## County of Hawai'i PLANNING DEPARTMENT

May 7, 2015

**SUBJECT:**      **Application:**      **PLANNED UNIT DEVELOPMENT (PUD-15-000031)**  
                  **Applicant:**            **RIEHM OWENSBY PLANNERS ARCHITECTS**  
                  **Owner:**                 **RLF MAKALEI PROPERTIES, LLC**  
                  **Request:**                **An Agricultural PUD at Makalei**  
                  **Tax Map Key:**        **7-2-007:011, 7-2-035:001 through 045, 047 & 048**

## Exhibit 8: Street Lights

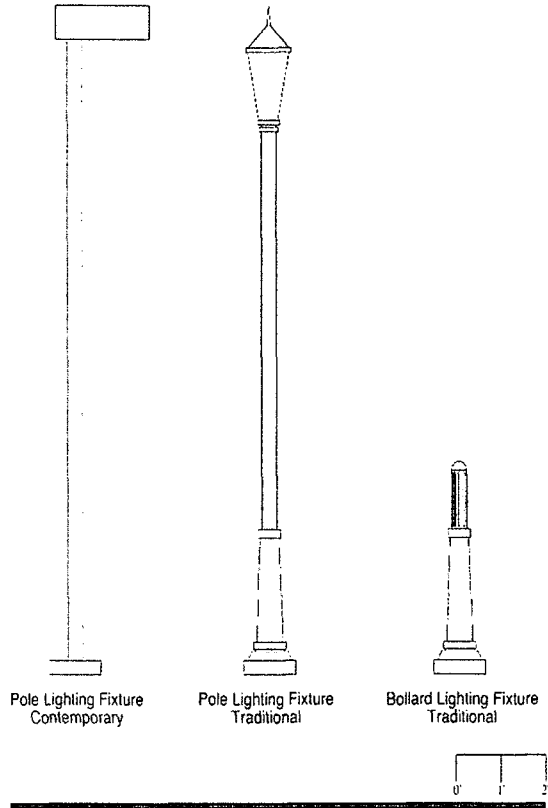
6. Variance Nos. 19 and 20 from HCC Sections 23-93 and 23-94. DPW Traffic Division will not review or comment on striping and street lights for private roads. The engineer of record should be required to design in accordance with

## Exhibit 10: Right of Way Improvement

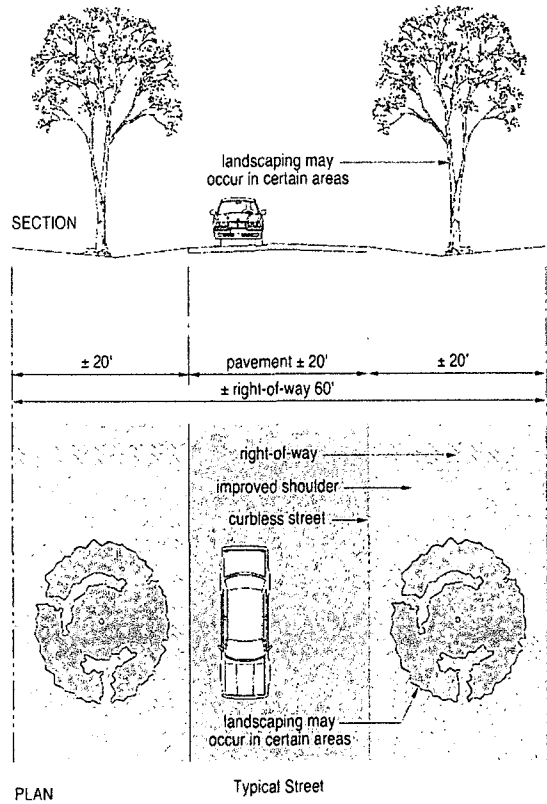
1. Variance request No. 13 HCC Section 23-34. We question both the necessity and appropriateness of this request.
2. Variance request No. 15 from HCC Section 23-41. A specific right-of-way and pavement width must be specified by the applicant and/or required by the Planning Director for clarity of plat and plan review rather than the + or - widths in Section 5.4, exhibits 10 and 11 and A-4.

7. Variance Request No. 21 from Section 23-95. Exhibits 10, 11 and A-4 do not specify the proposed pavement section or shoulder and swale design. The applicant requests the standard details and specifications be waived but does not propose alternative details and specifications. Design standards are necessary to conduct a proper construction plan review. The required rights-of-way should be improved in accordance with HCC Sections 23-86 or as specified in a pavement justification report by a licensed civil engineer for forecast traffic volumes and for a declared pavement life. Shoulders and swales should be graded and stabilized to the right-of-way or easement width exclusive of cut and fill slopes providing for the AASHTO recommended clear zone and for collection and conveyance of storm runoff in accordance with the County Storm Drainage Standards.
